A D D E N D U M N O . 1

Date: March 28, 2011

Issued by: Sacramento City Unified School District

Project: PC11-700-0151, Leonardo da Vinci Parking Lot Project

Amended plans/notes provided by Laugenour and Meikle Engineering. Sheet 5 is attached with changes on Construction Notes 15, 28, and 38.

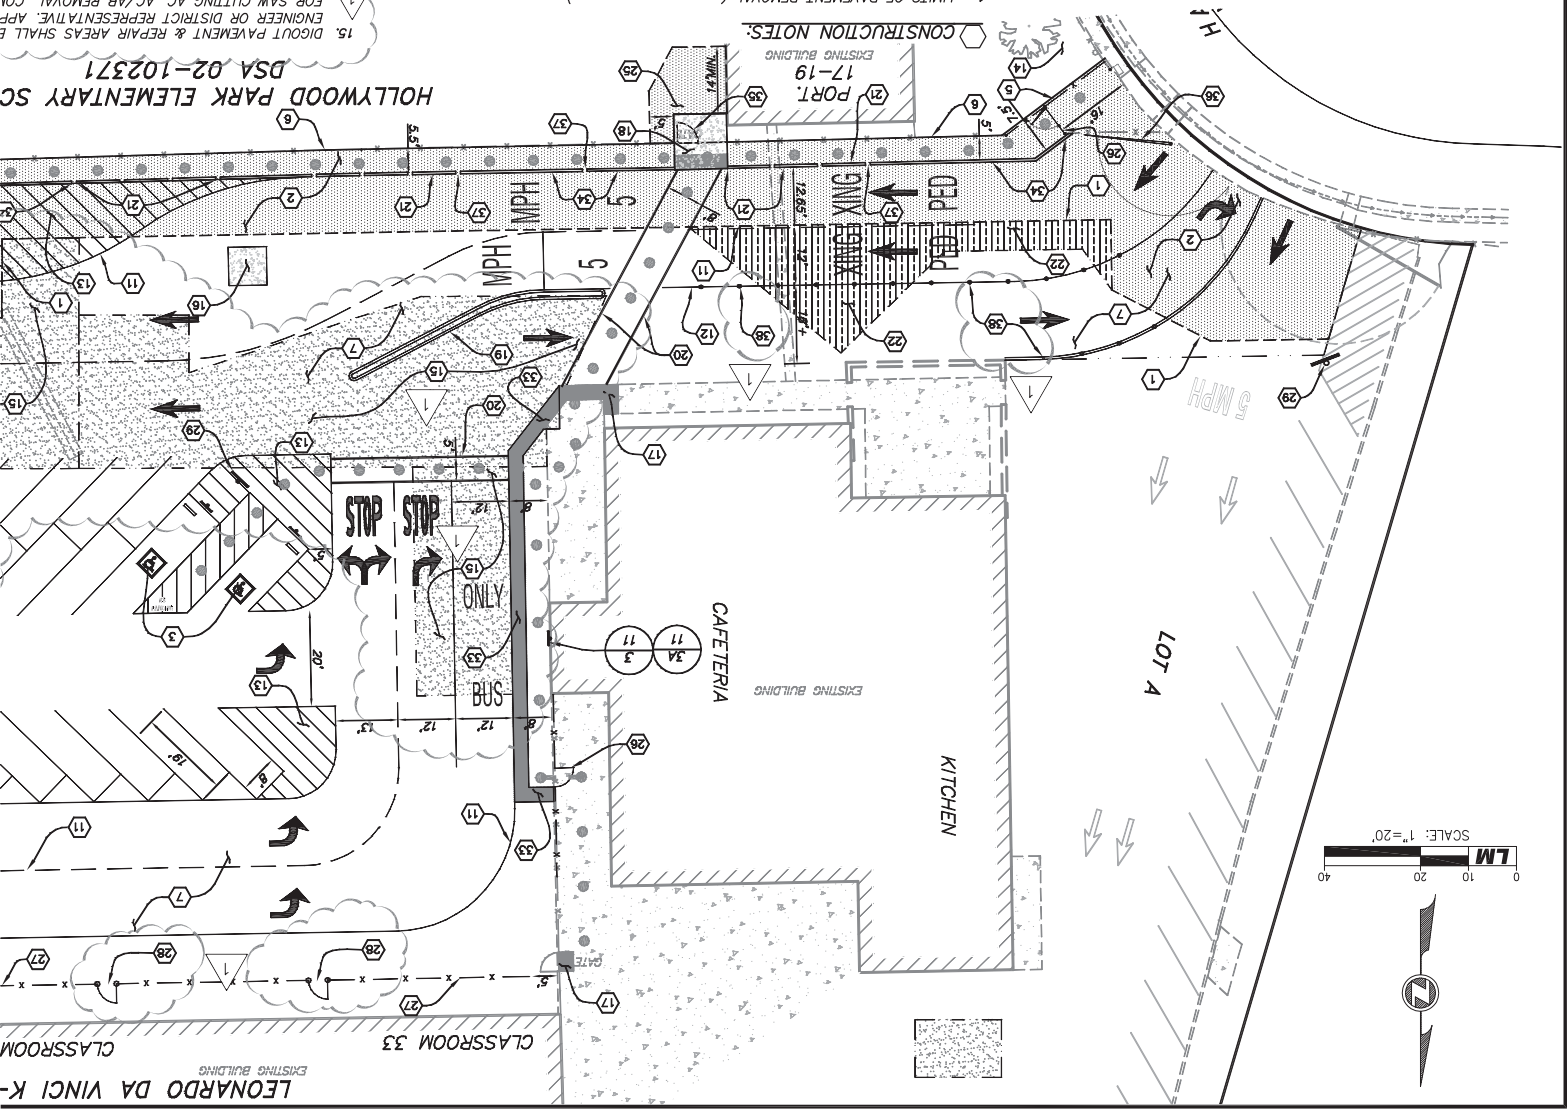
Item 2: Construction Note 15, Sheet 5 is revised as follows:

15. DIGOUT PAVEMENT & REPAIR AREAS SHALL BE MARKED IN THE FIELD BY ENGINEER OR DISTRICT REPRESENTATIVE. APPROXIMATE LOCATIONS ARE SHOWN FOR SAW CUTTING AC, AC/AB REMOVAL, COMPACTION OF EXISTING AB AND INSTALLATION OF 4" AC & 8" AB OVER COMPACTED SUBGRADE. ESTIMATED AREA OF DIGOUT IS 12,000 SF.

Item 3: Construction Note 28, Sheet 5 is revised as follows:

28. INSTALL 4' WIDEx42"HIGH PEDESTRIAN GATE (5 TOTAL) PER DETAIL 10, SHEET 8.

Item 4: Construction Note 38 added to Sheet 5 and reads as follows:

38. INSTALL 36" HIGH BOOMERANG TD5200 SURFACE MOUNT REBOUNDABLE DELINEATOR, OR EQUIVALENT, AT 8' O.C. (16 EACH)

This change is shown on Sheet 5 as Revision 1, Addendum No. 1.

This change is shown on Sheet 5 as Revision 1, Addendum No. 1.

This change is shown on Sheet 5 as Revision 1, Addendum No. 1.
